SITE PLAN REVIEW AND APPEARANCE BOARD

Meeting: December 11, 2019 | File No.: 2020-043-SPM-SPR-CLII | Application Type: Delray Oasis Business Park

SITE PLAN REVIEW AND APPEARANCE BOARD STAFF REPORT

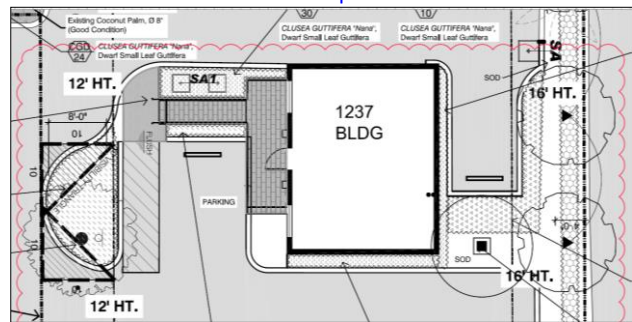
As mentioned, the proposed Class II Site Plan modification is essentially a modification of the previous Class III Site Plan modification (2018-013). The previously approved Class III Site Plan modification included landscaping that met the LDR requirements and was reviewed by the City's Senior Landscape Planner. The changes proposed with the Class II Site Plan occur only in the northeast corner of the site as a result of the new 1237 building, ADA ramp, and handicap parking space conversion which required the reconfiguration of the landscape island. The changes are the replacement of Maki Podocarpus hedges and Dwarf Small Leaf Guttifera in the parking island south of building 1237 with Lilyturf. The lilyturf provides a lower growth height than the Podocarpus which furthers the landscape compliance of the sight line visibility triangle. The other change within the parking island is the adding of additional paving to provide access to the ADA ramp, and the reduction and reconfiguration of the Dwarf Small Leaf Guttifera shrub. Lastly, around the perimeter of building 1237 the plans proposed the replacement of the Red Tip Cocoplum and Sod with a reconfigured row of Dwarf Leaf Guttifera, Sod, and Red Tip Cocoplum. The landscape modifications shown in the proposed landscape plan are minor and still meeting the LDR requirements for the whole site.

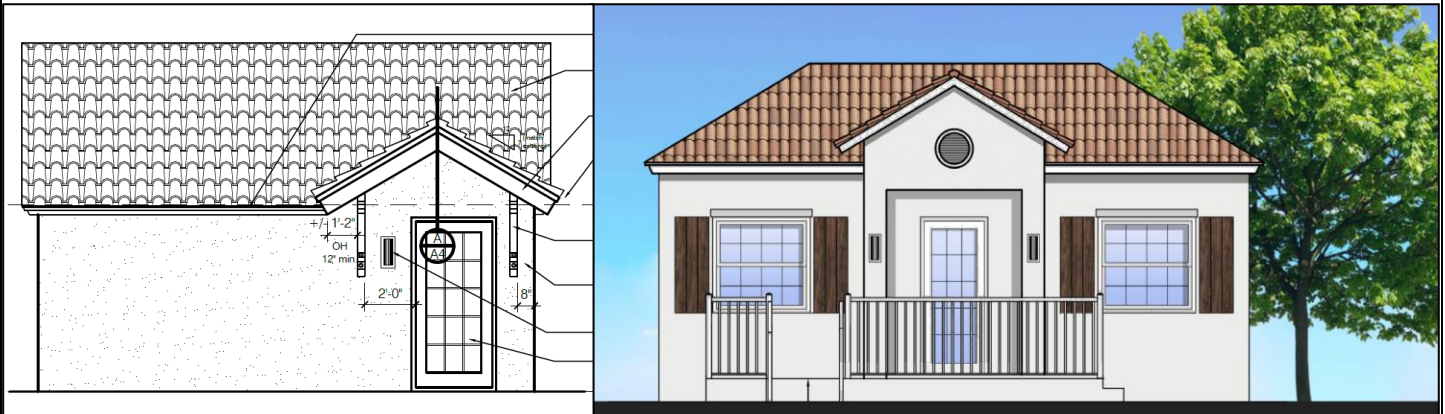
Architectural elevation plans provided propose the creation of a new one-story 549 sf masonry block building 1237 to replace the previous 392 sf prefabricated metal garage structure. The existing metal structure will be demolished for the new building to be built. The new building, which is 157 larger in square footage, is being proposed to be constructed in the same location as the previous building. The proposed masonry building includes a red barrel tile roof, Response Gray SW 7015 painted stucco cladding, Elder White SW 7014 painted fascia, transparent glass windows and doors with bronze aluminum anodized frames, Moonlight Mahogany wood finished shutters and dark bronze anodized color aluminum handrails. In addition, the north façade of the building includes illuminated wall scones and a vented louver medallion.

The proposed architectural elevation changes are compatible and harmonious with the surrounding properties. The modifications are consistent with the recently approved architectural elevation changes for the other buildings located at this development and will represent an aesthetic improvement.
